BONIVITAL POOL . HOT TUB INSTALLATION

CITY OF WINNIPEG
BONIVITAL POOL HOT TUB INSTALLATION
 1215 ARCHIBALD ST.

PROJECT DATA, SITE KEY PLAN & ELEVATION

PROJECT No. 82510 DRAWING No. A-1 R1

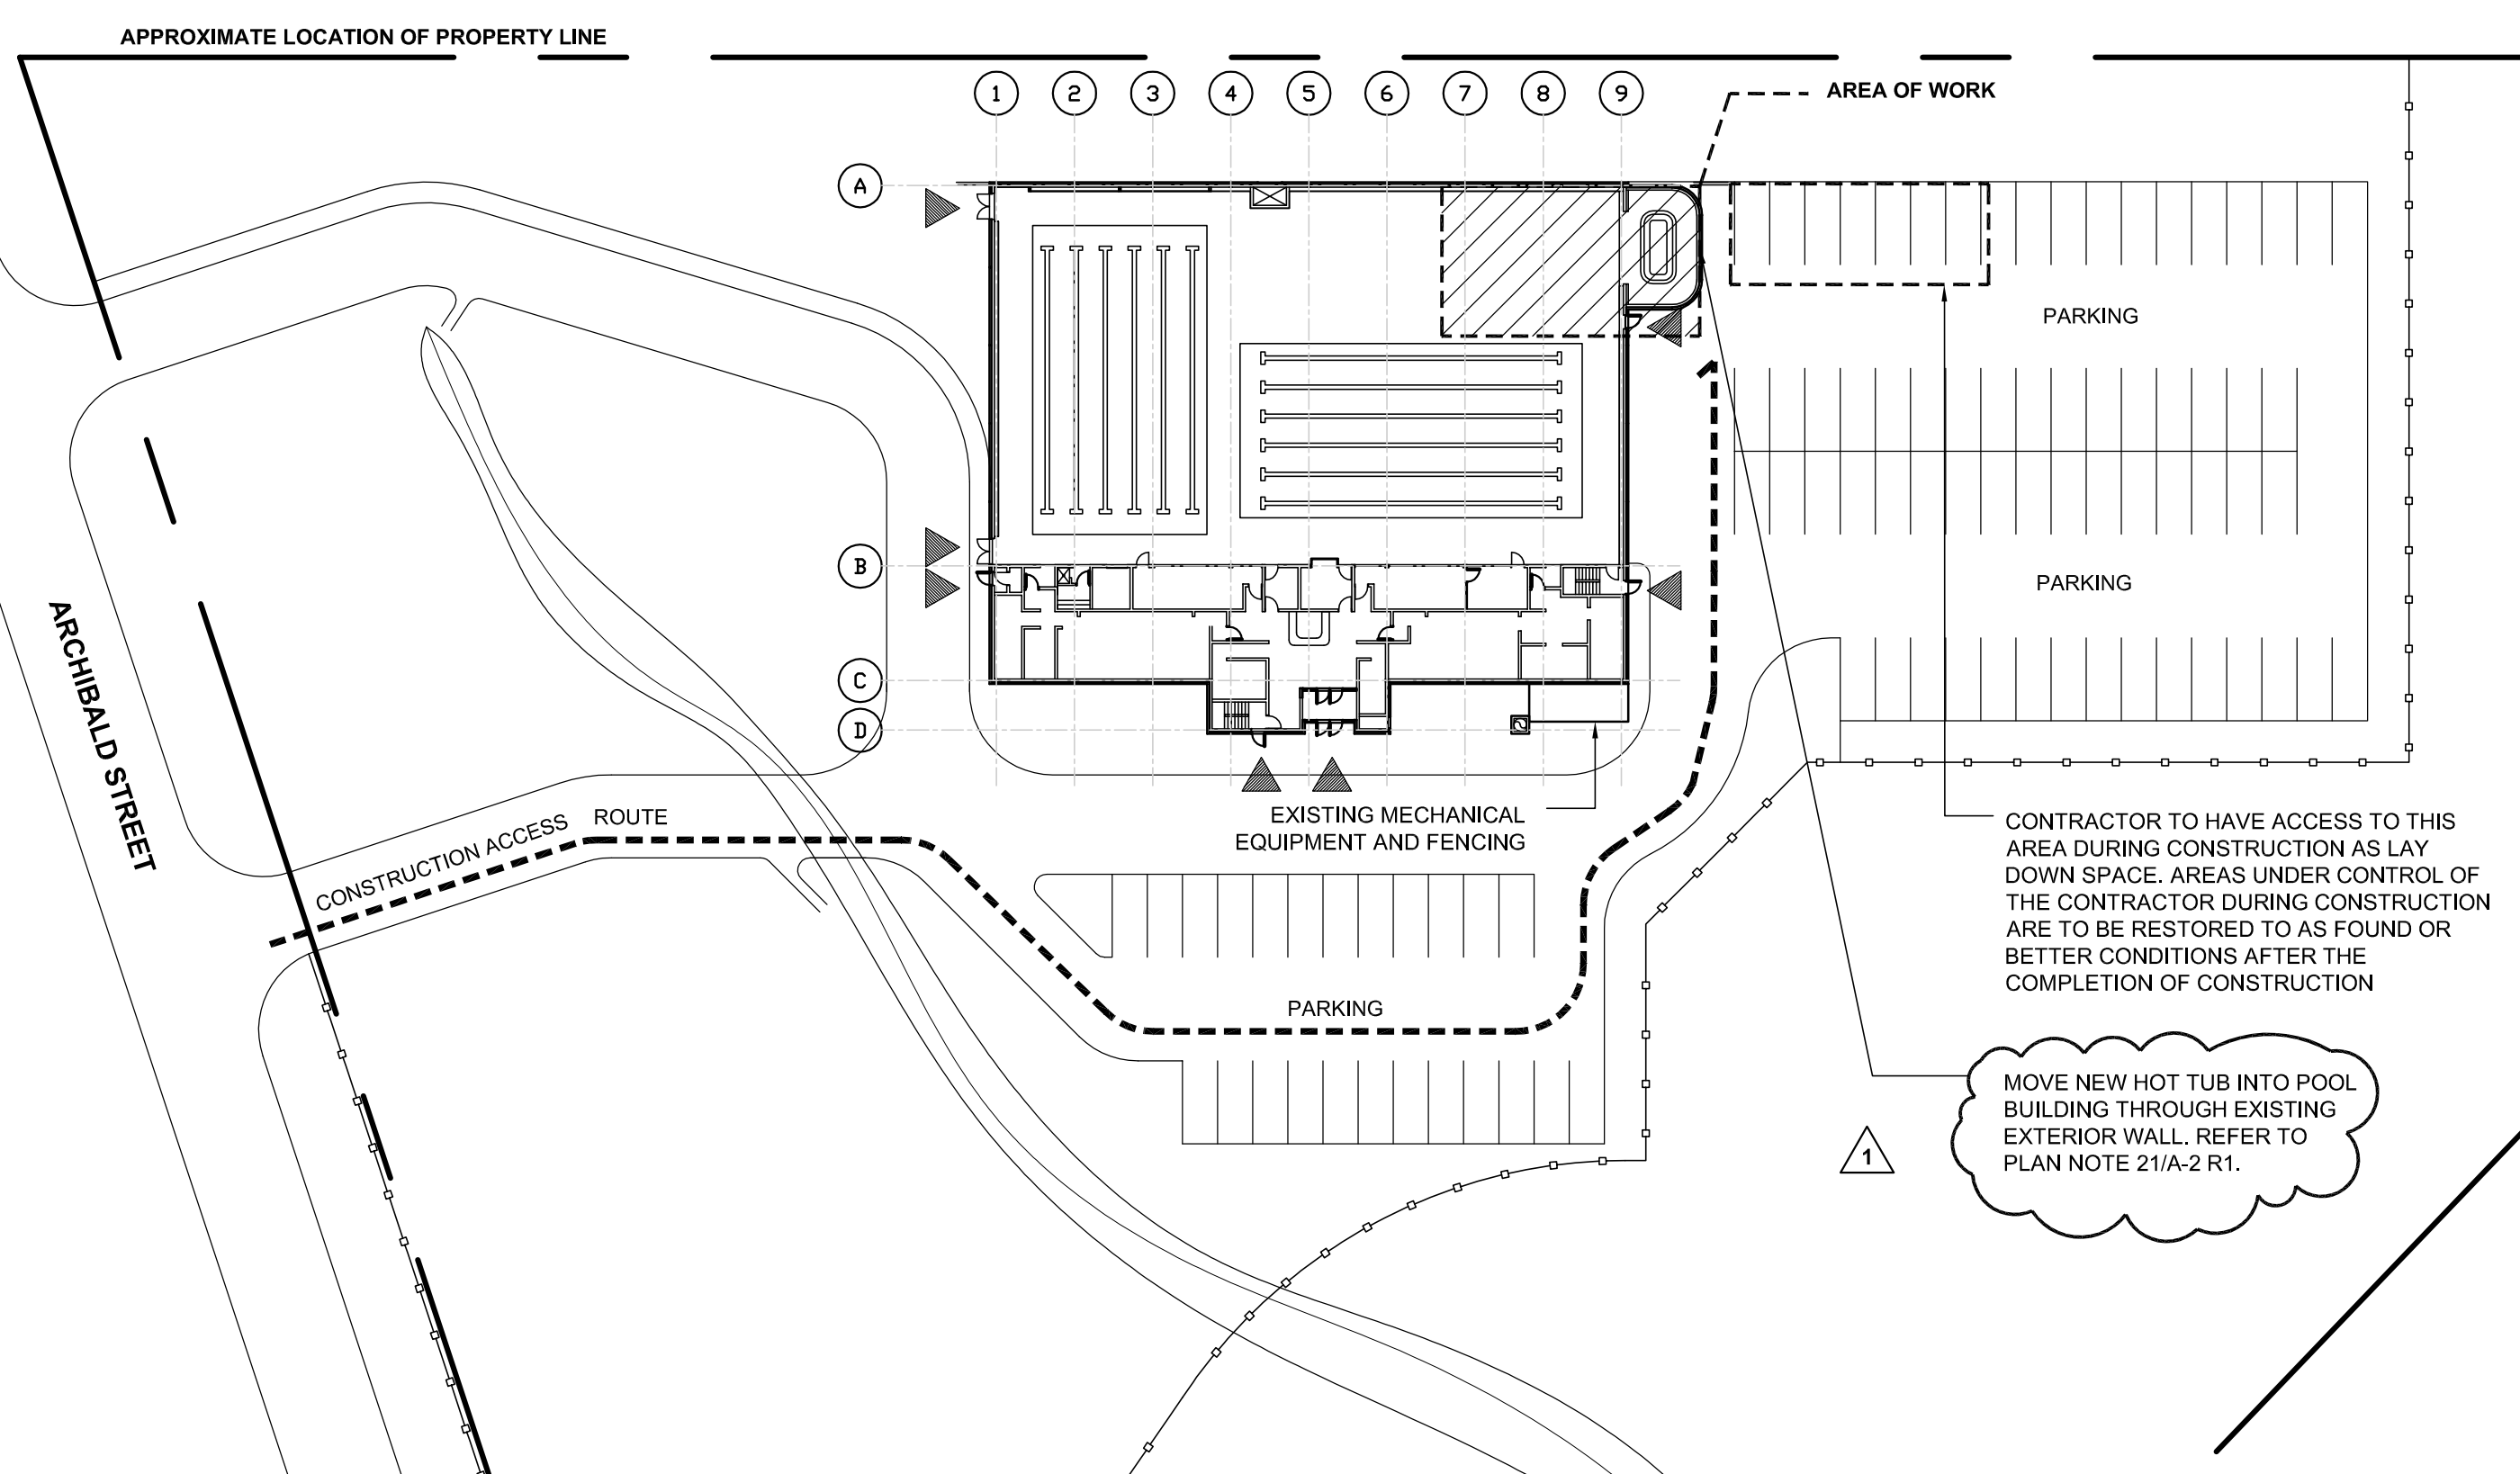
DELETE

DELETE REFERENCE TO REMOVAL AND REPLACEMENT OF GLAZING AS PER ADDENDUM #1
